**Planning Commission
Staff Report**

January 22, 2014
Item 6.a.

- SUBJECT:** Work Session for P13-2078
- APPLICANT:** SummerHill Apartment Communities
- PROPERTY OWNER:** Las Positas Property, LLC
- PURPOSE:** Work Session to review and receive comments on a Preliminary Review application to demolish the existing office building and construct 177 apartment units and related site improvements on a 5.9 acre site

Revised Plan

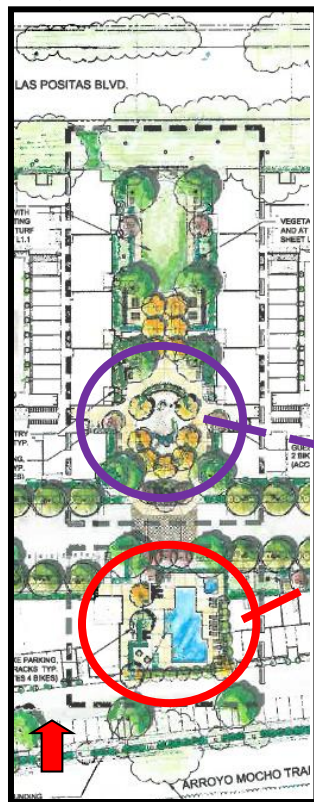
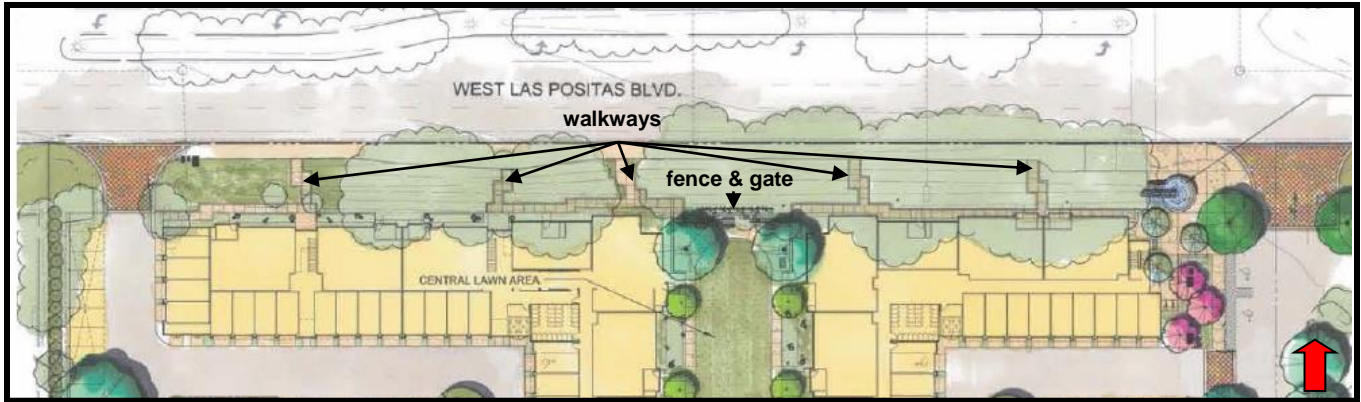
- 1. Site Layout.** In response to Commission’s comments regarding the pool location, size of the common open space area, and size of the tot lot, the applicant has revised the site layout to: 1) relocate the pool to the north between Buildings A and B; 2) relocate the tot lot to the south and reduce its size from 2,400 sq. ft. to 2,080 sq. ft.; and 3) increase the square footage of the common open space area from 2,528 sq. ft. to 4,464 sq. ft. In addition, walkways have been added to connect the sidewalk along W. Las Positas Boulevard to the proposed residential development. In consideration of security of the private open space area, a fence and a gate are proposed at the northern entrance of the open space. Please refer to the exhibits below and the following page for the revisions.

Discussion Point No. 1: Is the new location of the pool and other amenities, and access from W. Las Positas acceptable?

Revised Recreation Facility Locations

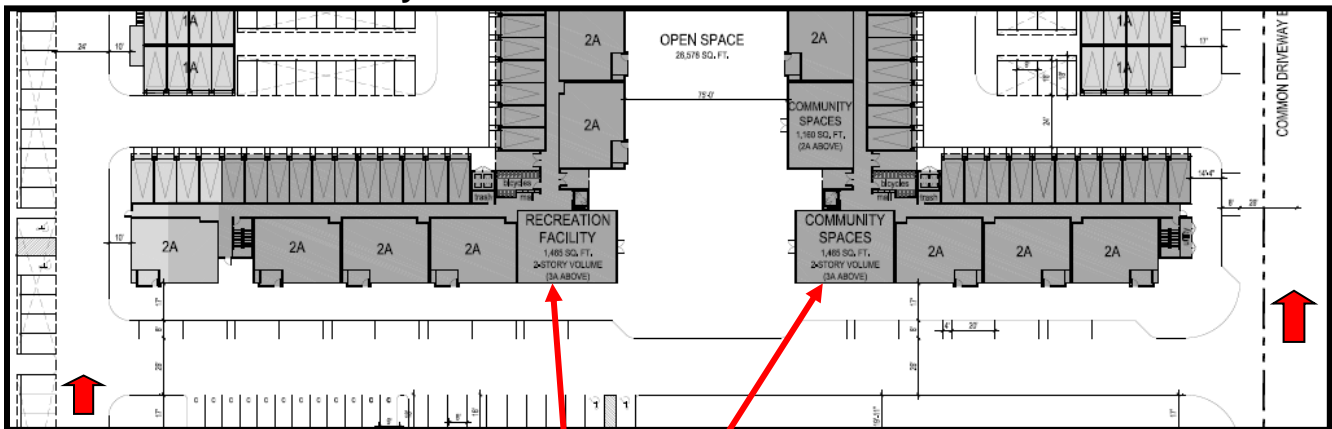
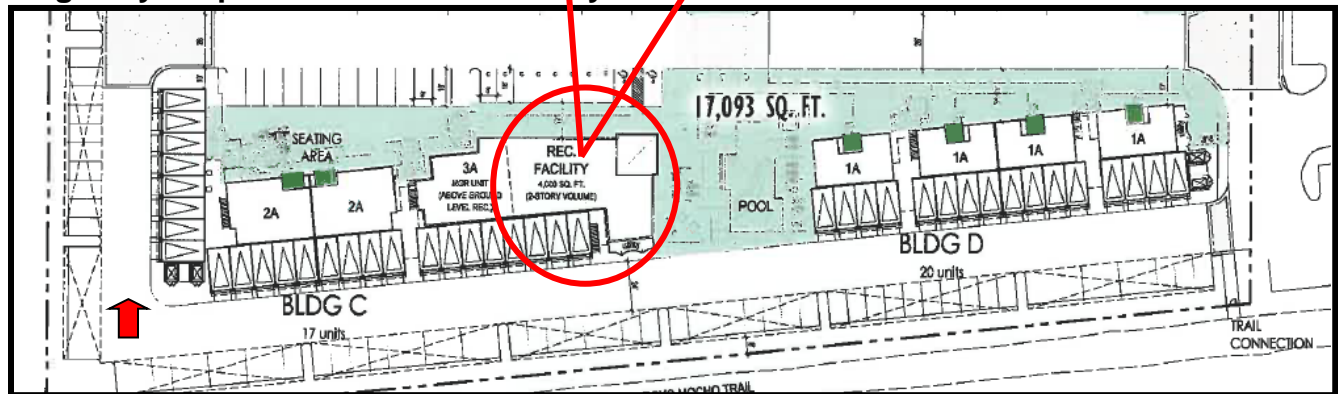
To accommodate to the pool and tot-lot location swap, the applicant has relocated the recreation facility. The recreation facility was originally proposed to be located in the eastern end of Building C. The applicant now proposes to locate the facility in both Buildings A and B. Building A would have the fitness facility and Building B would have a lounge area. Please see exhibits on the following page.

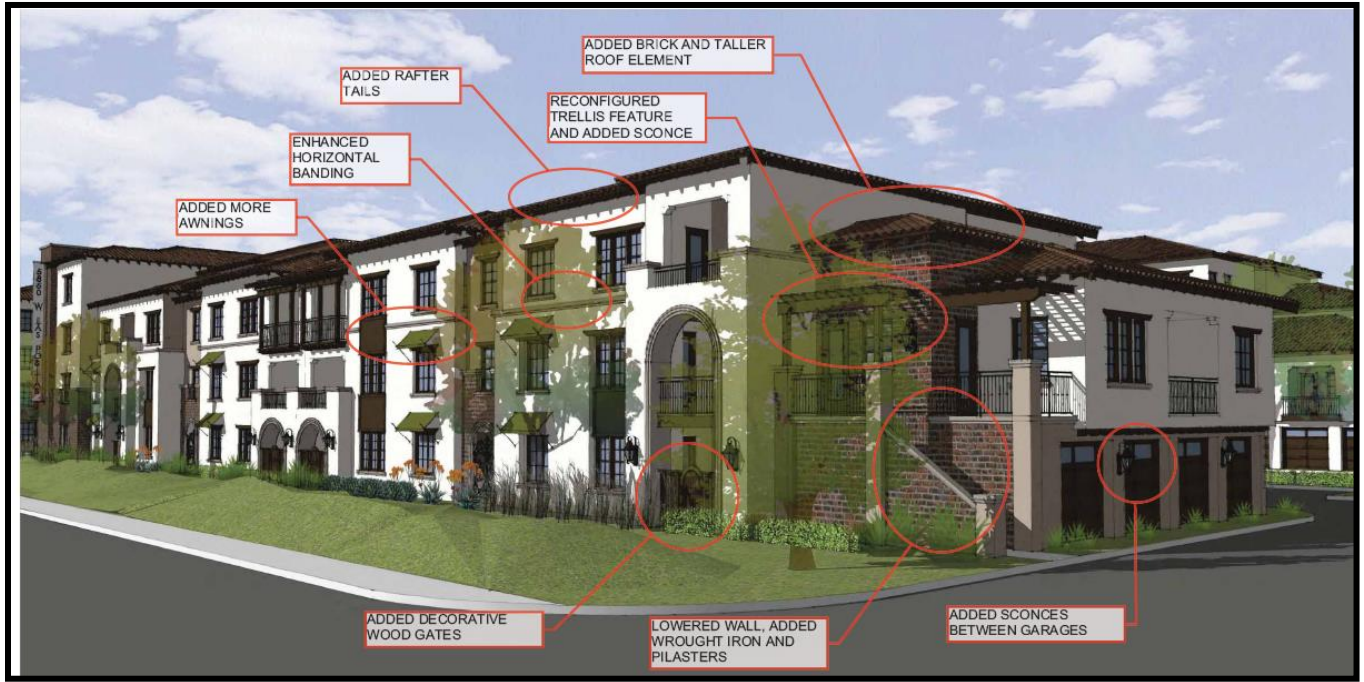
2. Building Height. Instead of two three-story buildings facing Arroyo Mocho, the applicant proposes two buildings which have a three-story component facing north and a two-story component facing south (the arroyo) to reduce the building mass and to reduce visual impacts to the existing residential community to the south. The two-story portion would measure approximately 29'-6" to the top of a sloping roof, and the height of the three-story portion would measure approximately 38 feet to the ridge of the roof. Please see the cross-section and the south elevations of Buildings C and D below. The cross-section also shows the distance to an existing two-story home on the south side of the arroyo.

Discussion Point No. 2: Is the revised proposal for massing at the rear of the site with two and three story building combinations acceptable?

Revised Plan

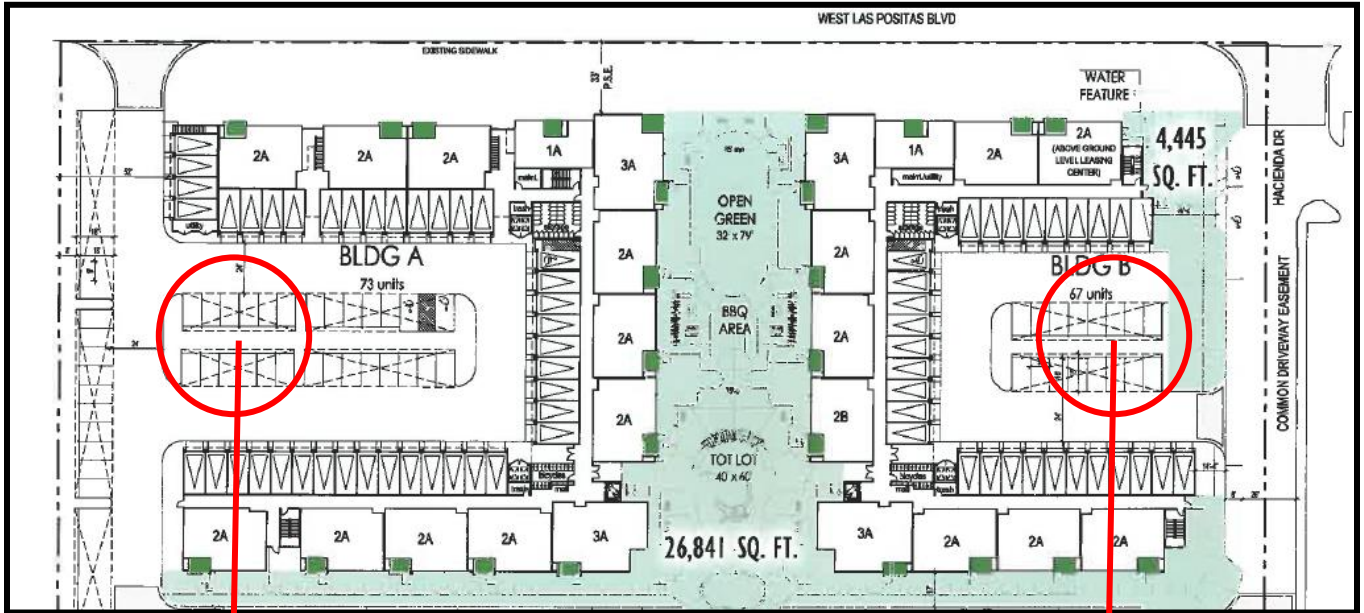
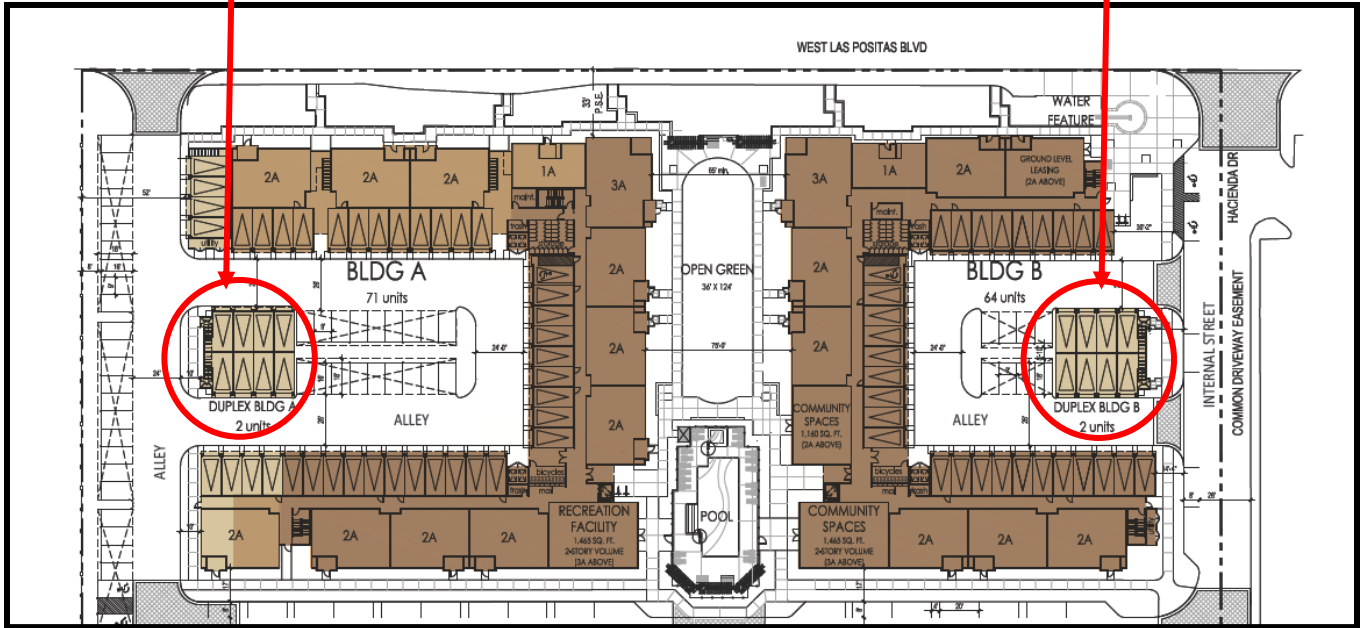
- 4. Redistribution of Dwelling Units.** As a result of lowering the building height of the buildings located in the southern portion of the site (Buildings C and D), the applicant has relocated four units (referred to as duplex units) in the middle of Buildings A and B, changing the middle carport area to a combination of carport and two-story building (one living floor above garage) to meet the required density.

Discussion No. 4: Is the revised dwelling-unit with living units over parking by Buildings A and B acceptable?

Revised Plan

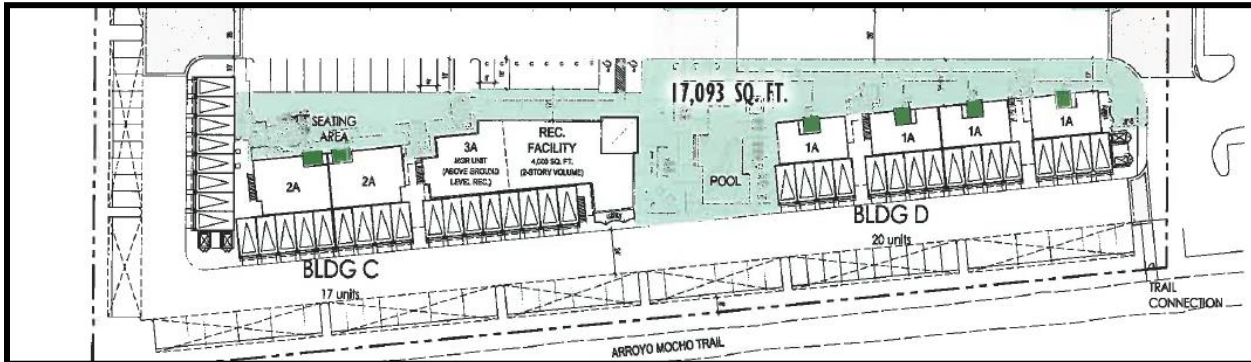
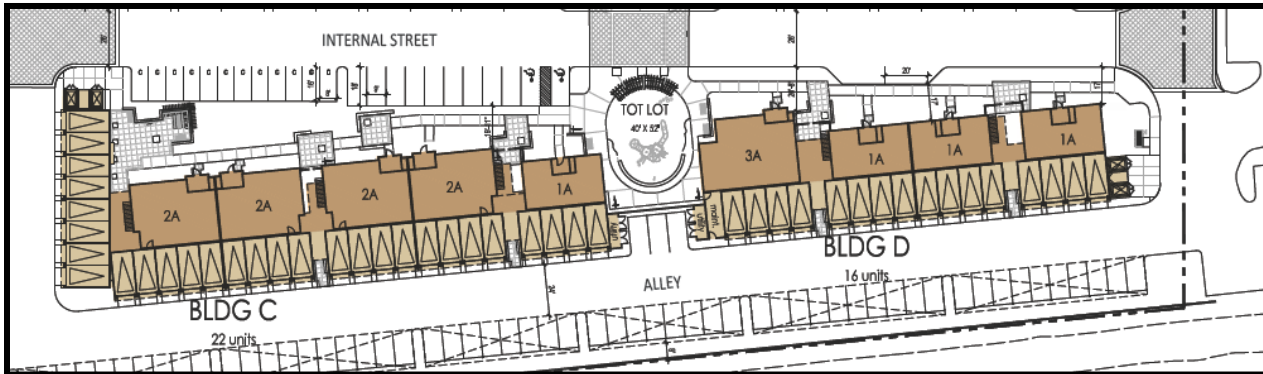
Additionally, the applicant has relocated five dwelling units to Building C and removed four units from Building D.

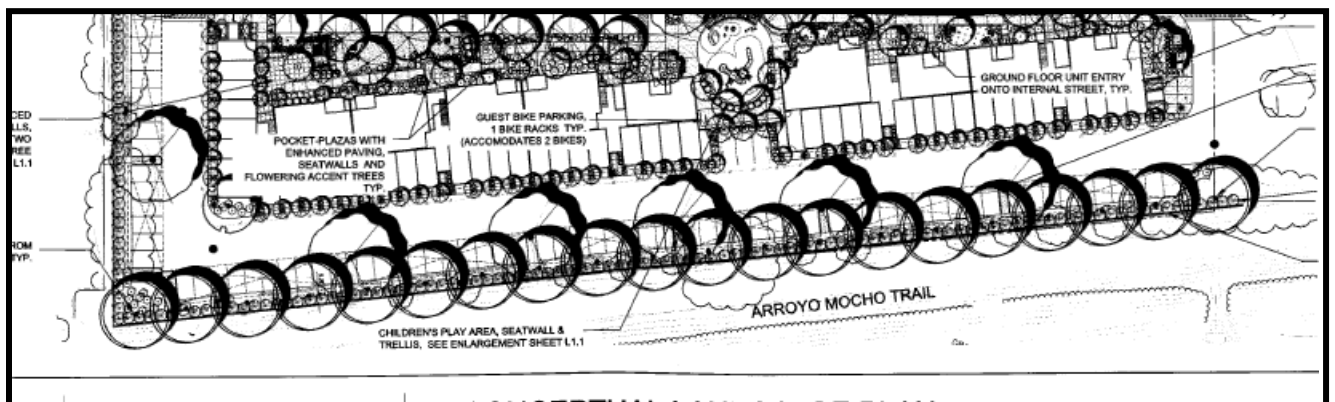
The southeast portion of Building B where the utility closet and one garage are proposed is set back approximately 5'-8" from the back of the sidewalk, not meeting the required eight-foot setback. This reduction resulted from adding the required parallel parking to entry street.

A4.2. Front setbacks shall be a minimum 8 feet from the back of sidewalk providing enough room for planting and privacy while still allowing a strong relationship between the units and street.

Discussion Point No. 5: Would the Planning Commission support the requested exception if the project were to move forward as proposed?

Planting Growth Photosimulations

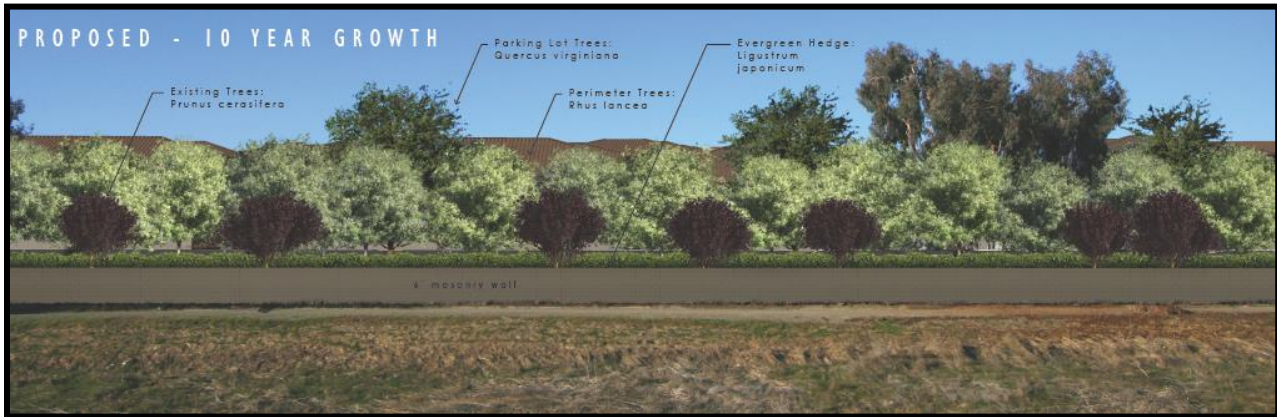
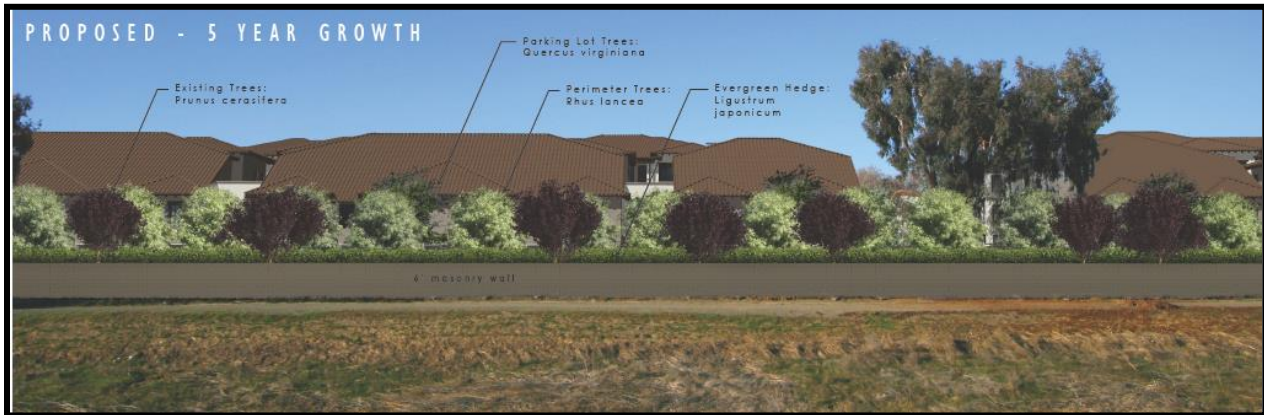
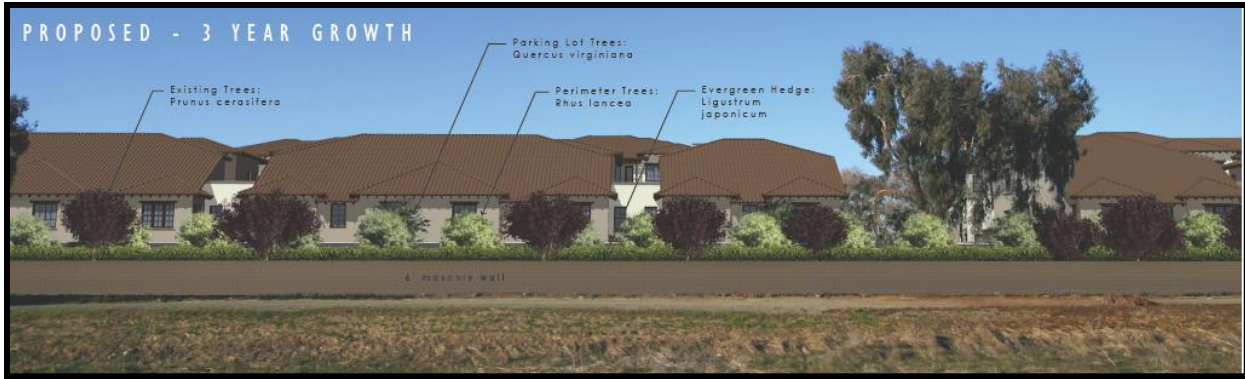
To screen the proposed development from the existing residential neighborhood located to the south, the applicant has revised the landscape plan at the southern property line. The existing trees (seven red ironbarks, 12 plums, and a cork oak) along the southern property line would remain. In a discussion with the project landscape architect, evergreen shrubs and Rhus lancea (African Sumac) trees would be planted to screen the future buildings. The evergreen shrubs would be trimmed to form a dense hedge. The applicant prepared photosimulations showing the planting along the southern property line at growth intervals of three, five, and ten years.

Discussion Point No. 6: Is the revised landscaping in the rear acceptable?
